Project	<b>IEEE 802.16 Broadband Wireless Access Working Group</b> < <a href="http://ieee802.org/16">http://ieee802.org/16</a> >	
Title	<b>Correction of inconsistencies for 802.16e D5 OFDMA symbol clock frequency tolerance</b>	
Date Submitted	<b>2004-11-04</b>	
Source(s)	Juergen Otterbach Joerg Schaepperle Roland Muenzner Torsten Fahldieck Alcatel SEL AG	Voice: +49-711-821-32255 Fax: +49-711-821-32453 <a href="mailto:juergen.otterbach@alcatel.de">juergen.otterbach@alcatel.de</a>
Re:	802.16e D5 September 2004	
Abstract	Correction of inconsistencies for 802.16e D5 OFDMA	
Purpose	Modification of symbol clock tolerances for OFDMA in 802.16e-D5	
Notice	This document has been prepared to assist IEEE 802.16. It is offered as a basis for discussion and is not binding on the contributing individual(s) or organization(s). The material in this document is subject to change in form and content after further study. The contributor(s) reserve(s) the right to add, amend or withdraw material contained herein.

# Correction of inconsistencies in 802.16e D5 OFDMA symbol clock frequency tolerance

Figure 2: Signal-to-interference ratio (SIR) as a function of the absolute tolerance of the sampling clock  $F_s$  in percent of the subcarrier spacing  $\Delta f$

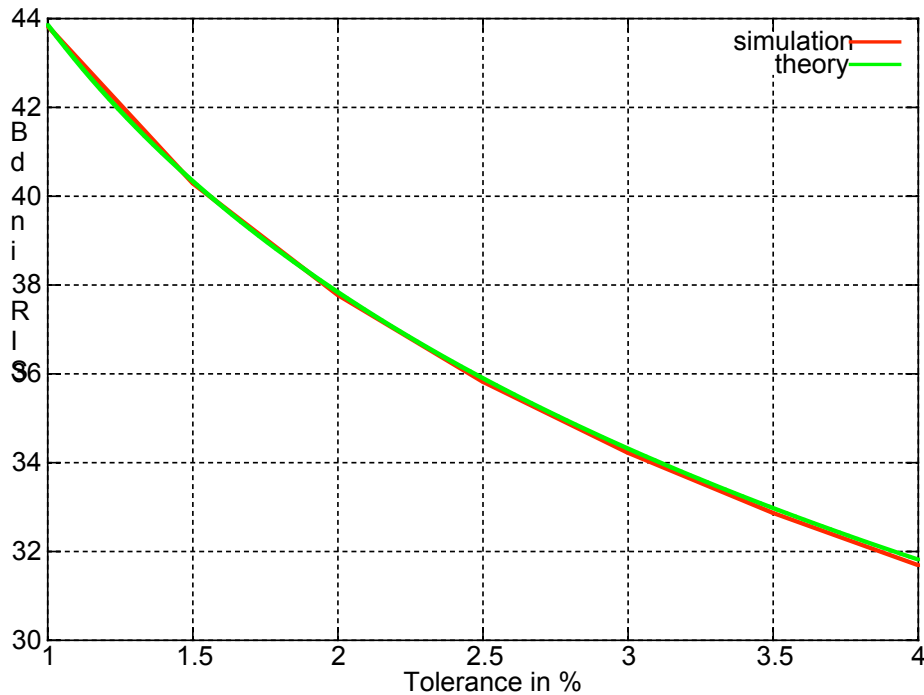
As an indication Figure 2 shows the resulting SIR values in function of the tolerance for the sampling clock frequency for a range of values, that still would leave some margin to the SNR requirement of 24.4 dB for 64 QAM.

A symbol clock frequency tolerance of 2 % of the subcarrier spacing on the other hand, as currently required in 802.16-REVd/D5, results due to the above relation between the symbol clock and the sampling clock frequency in a much higher tolerance for the sampling clock frequency. Therefore this requirement on the symbol clock frequency is not sufficient.
